In response to the Notice Regarding Drawings mailed July 17, 2006 herein, corrected Figs. 11, 15 and 20, each labeled "Replacement Drawing," are supplied herewith and originals of those figures are supplied with annotations indicating the changes made therein, in producing the corrected figures.

RESPONSE TO NOTICE REGARDING DRAWINGS**TRAVERSE TO INDICATION THAT FIG. 20 DOES NOT SATISFY THE "VIEWS" REQUIREMENT UNDER 37 C.F.R. 1.84 (h)**

FIG. 11

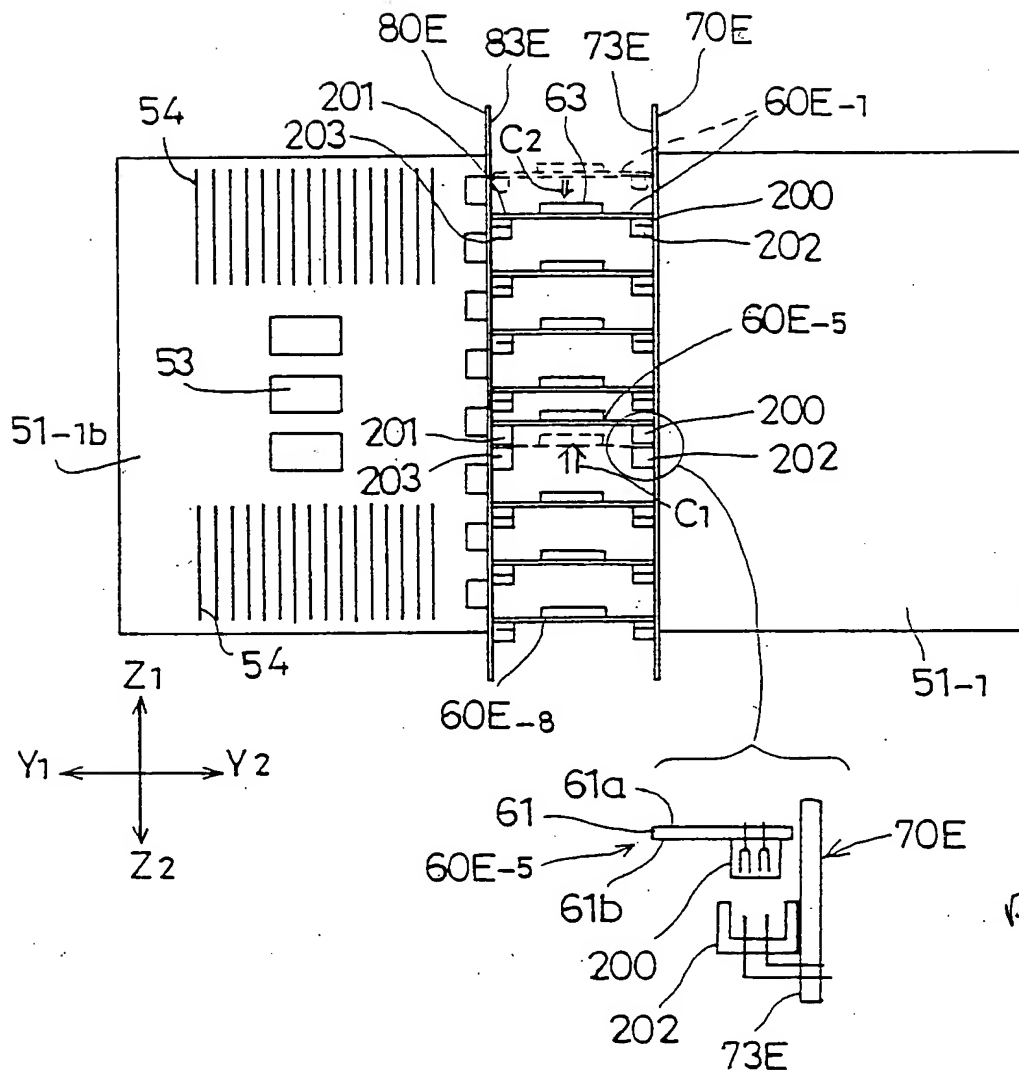
In the sheet containing Fig. 11, a new legend Fig. 11-1 has been placed adjacent the separately illustrated structure disposed below (in the Z2 direction) the main structure illustration of Fig. 11, the enlarged structure of Fig. 11-1 corresponding to the portion of the structure of Fig. 11 designated by a circle in the original Fig. 11.

Fig. 11 has been further labeled with - - Fig. 11-1 - - beside the elements in the bracketed grouping at the bottom of Fig. 11, which corresponds to an enlarged view of the same such elements 200 and 202 in the encircled portion of the structure shown in the upper portion of the sheet bearing Fig. 11.

FIG. 15

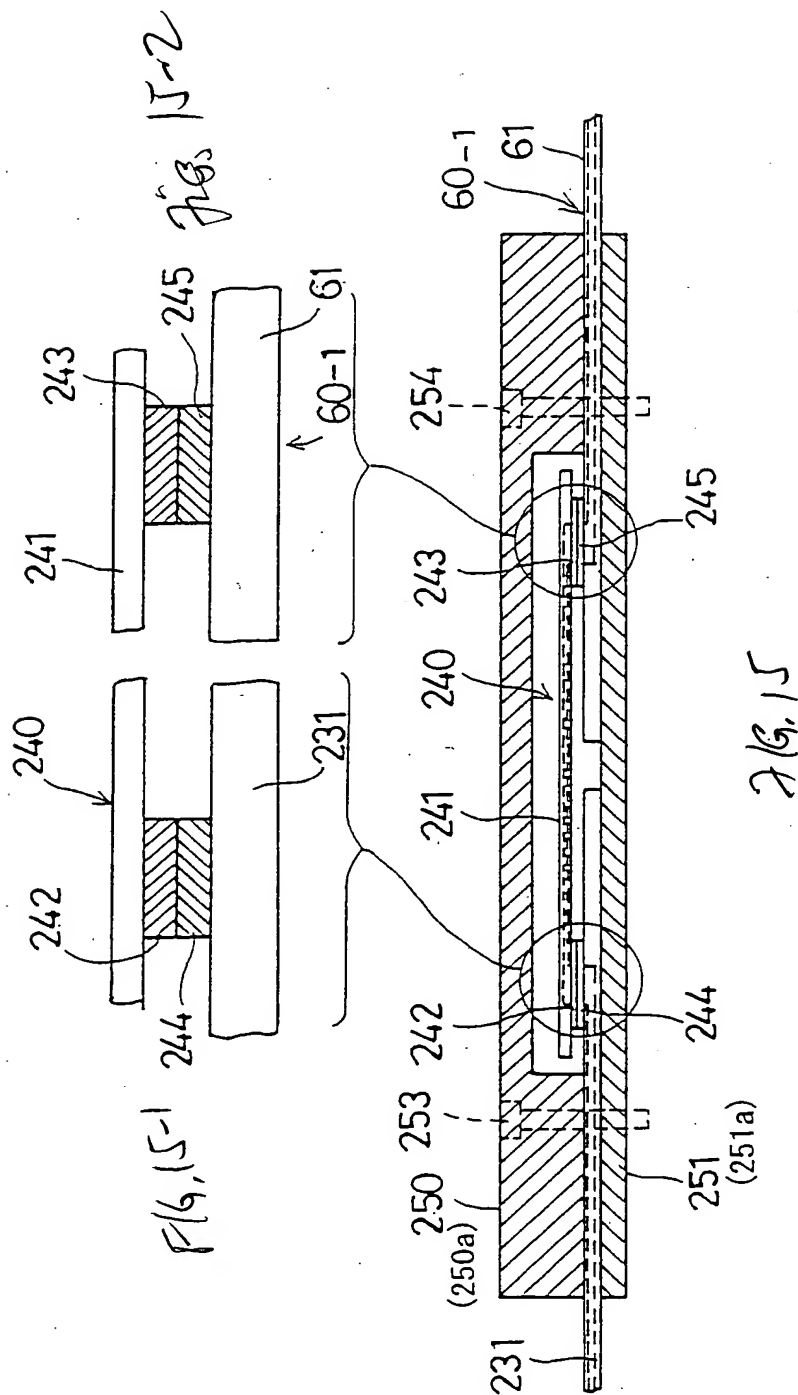
Fig. 15 has been corrected by moving the legend "Fig. 15" to the bottom of the page adjacent the completed structure as originally illustrated at that location and new legends Fig. 15-1 and Fig. 15-2 are placed to the left and right respectively, of the enlarged portions of the structures identified by circles, overlaid on the structure of Fig. 15.

The sheet containing Fig. 15 has been modified to include labels "15-1 and 15-2" respectively presenting the enlarged views of a stacking connector 240 and a flat-cable unit 241 corresponding to respective portions of those same encircled elements as illustrated in the lower Fig. 15 structure. (To accommodate the use of the new Figs. 15-1 and 15-2 labels, the original Fig. 15 label has been relocated to the bottom of the page adjacent the lower structure.

As before noted, "Fig. 15" has been moved to the bottom of the page adjacent the complete structure illustrated on that page and new designations Fig. 15-1 and Fig. 15-2 are placed adjacent the left and right structures which illustrate on an enlarged scale the corresponding structure and circled in the Fig. 15 illustration.

The Brief Description of the Drawings at page 11, lines 1-2, has been supplemented to recite, after "Fig. 14" and before the "semicolon" the further description that - - , Fig. 15-1 is an enlarged view of the stacking connector 240 and Fig. 15-2 is an enlarged view of the flat -cable unit 241 which respectively appear in corresponding, circled portions of the structure illustrated in Fig. 15.
